Subject: Dresden Station Units 2 and 3
Quad-Cities Station Units 1 and 2
Zion Station Units 1 and 2
LaSalle County Station Units 1 and 2
Byron Station Units 1 and 2
Braidwood Station Units 1 and 2
Response to IE Bulletin 79-02,
Revision 2
NRC Docket Nos. 50-237/249/254/265/
295/304/373/374/454/455/456/457

RESPONSE TO REVISION 2 TO IE BULLETIN 79-02

SHEAR TENSION INTERACTION FOR
 $\frac{3}{8}$ " ϕ HILTI KWIK - BOLT
WEDGE ANCHOR (4.5 EMBDMENT)

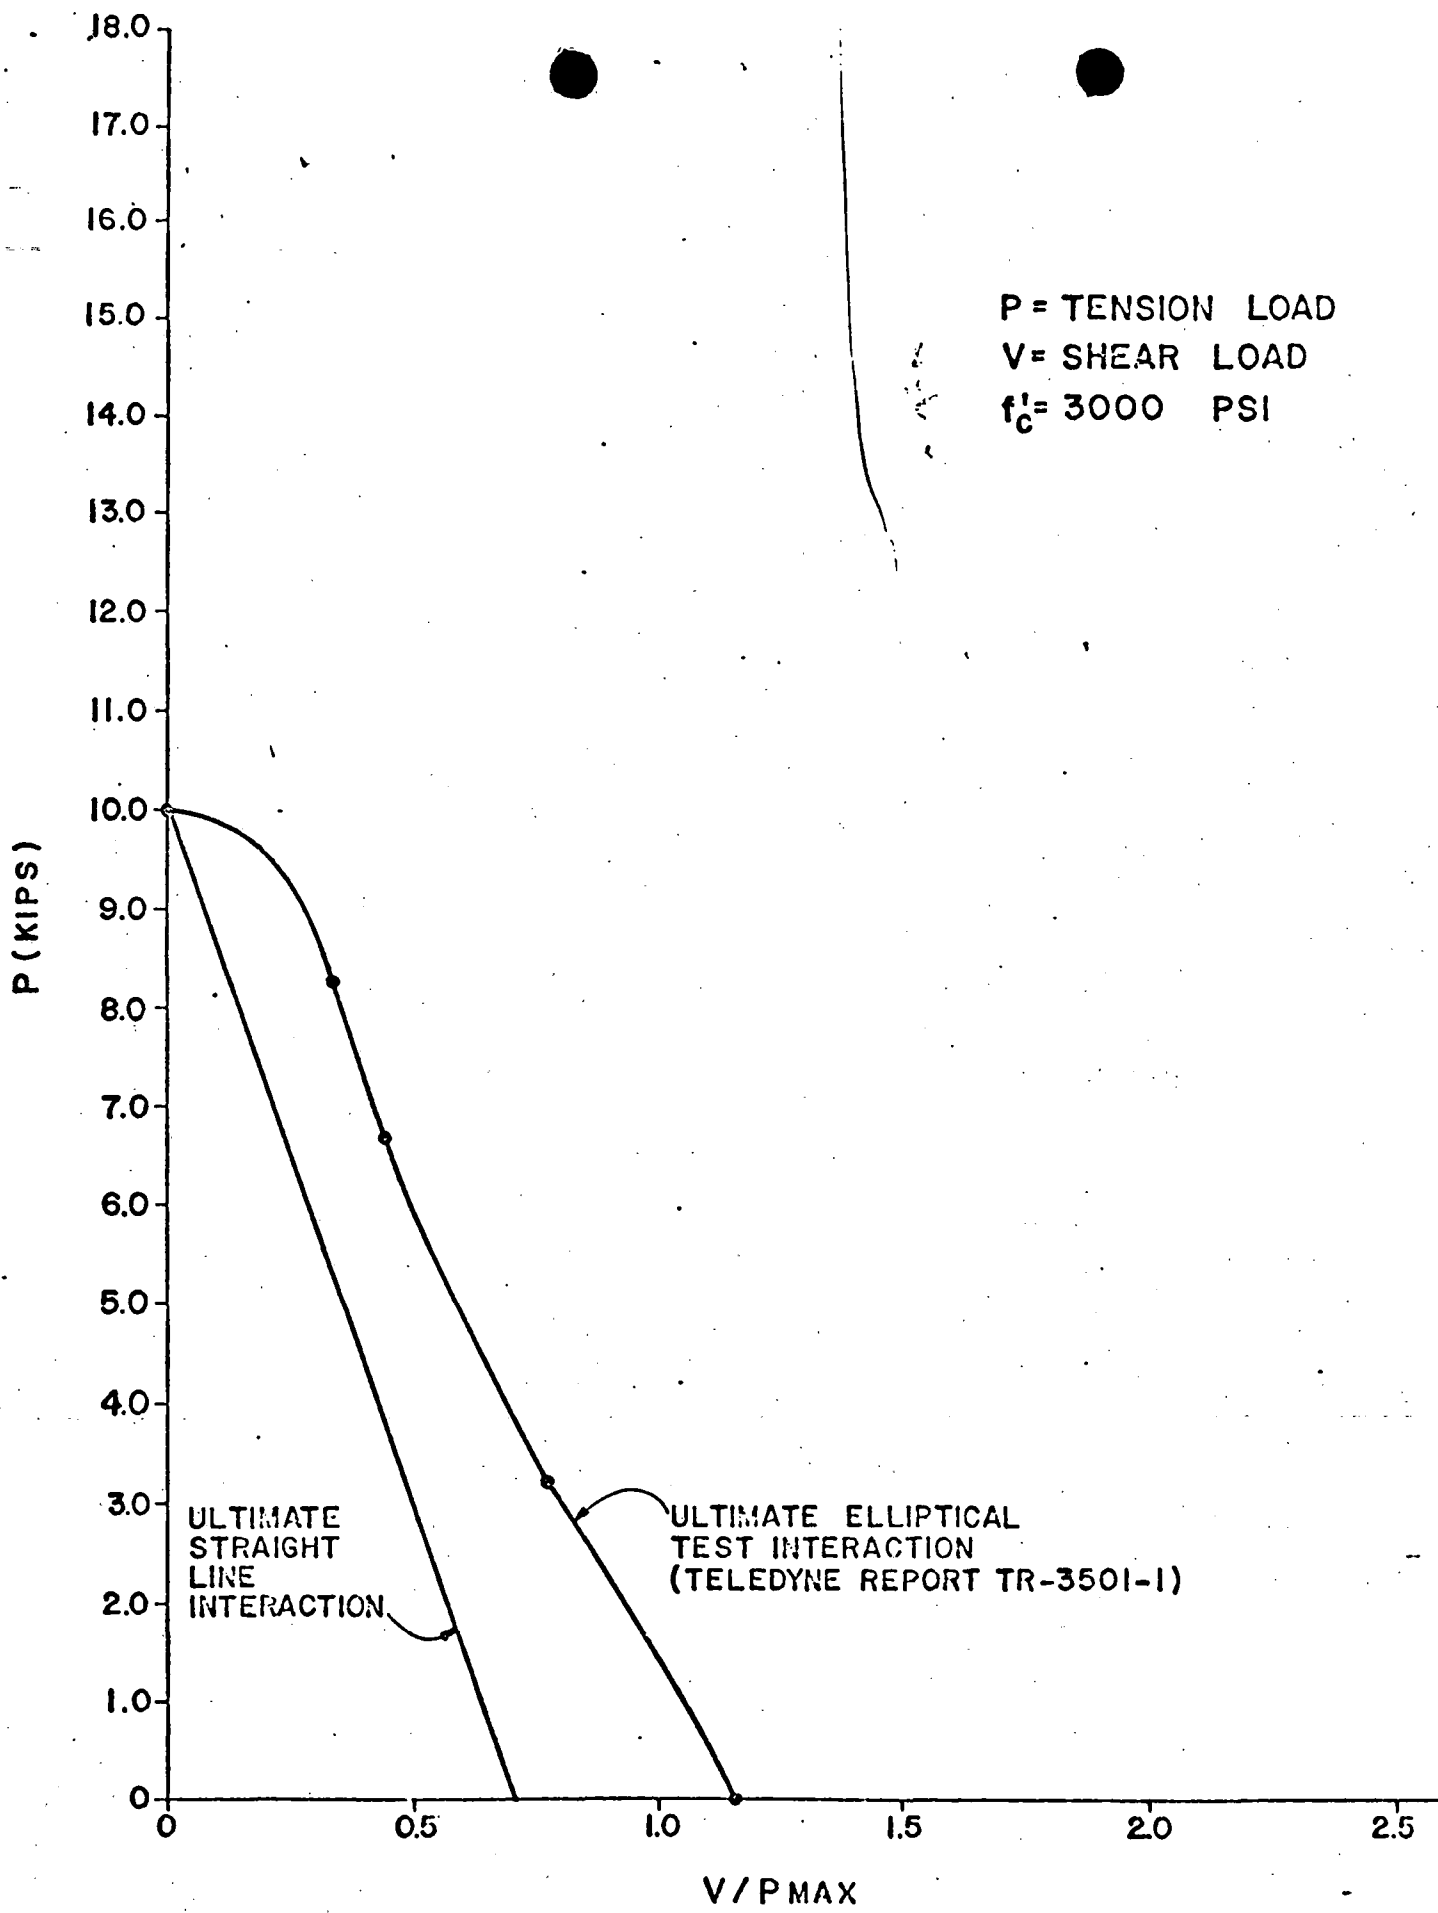
Tests performed on individual concrete expansion anchors and on concrete expansion anchored baseplate assemblies by the various expansion anchor manufacturers, and more recently by Teledyne-Brown Engineering, indicate that an elliptical interaction best defines expansion anchor capacity under combined tension and shear. The interaction equation would be of the following form:

The design of expansion anchored baseplate assemblies for Dresden, Units 2 and 3; Quad Cities, Units 1 and 2; Zion, Units 1 and 2; LaSalle County, Units 1 and 2; and Byron/Braidwood, Units 1 and 2, have been designed using a straight line interaction based upon the shear friction concepts using a coefficient of friction μ equal to 0.7. The resulting interaction curve is:

It can be seen by inspection that the straight line interaction curve will result in smaller allowable loads than the elliptical interaction for all circumstances in which

the ratio of T_{max} to U_{max} is less than 1.4. Attached are several typical ultimate shear tension interaction curves comparing the elliptical interaction determined by test with the straight line interaction used in design.
